Office Action Summary

10/781,775

QUYNH-NHU H. VU

**FIG. 2**

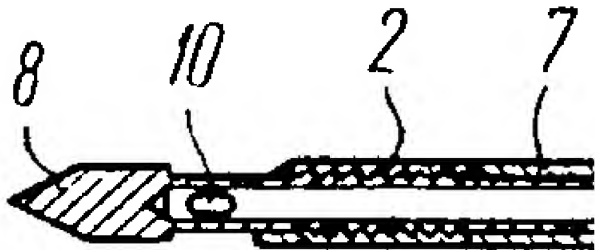
Claims 1, 3 are rejected under 35 U.S.C. 102(b) as being anticipated by Pshenichny et al. (US 3,750,667).

As best as understood, Pshenichny discloses a device comprising: a first elongated shaft 1 having a distal end and a proximal end and a first lumen extending there between; a needle 7 with a proximal end and a distal end and a needle lumen extending there between, the needle disposed within the first lumen of the first elongated shaft and extending from a proximal end of the catheter to a distal end of the catheter; a stop collar is a portion formed of a second set of male thread 2 corporate with a first set male thread of inside tube/needle 7 (Figs. 1-2 or see Fig. 2 below is enlarged); wherein rotation of the needle within the first elongated shaft can be caused longitudinal movement of the stop collar relative to the needle within the first elongated shaft because the threading motion step of two thread surface engaged with each other, the positioning of the stop collar/female thread section located within the first elongated shaft controlling a variable extent to which the needle may be extended beyond the distal end of the first elongated shaft; a means/restrictor 12, 13 for preventing rotation of the stop collar
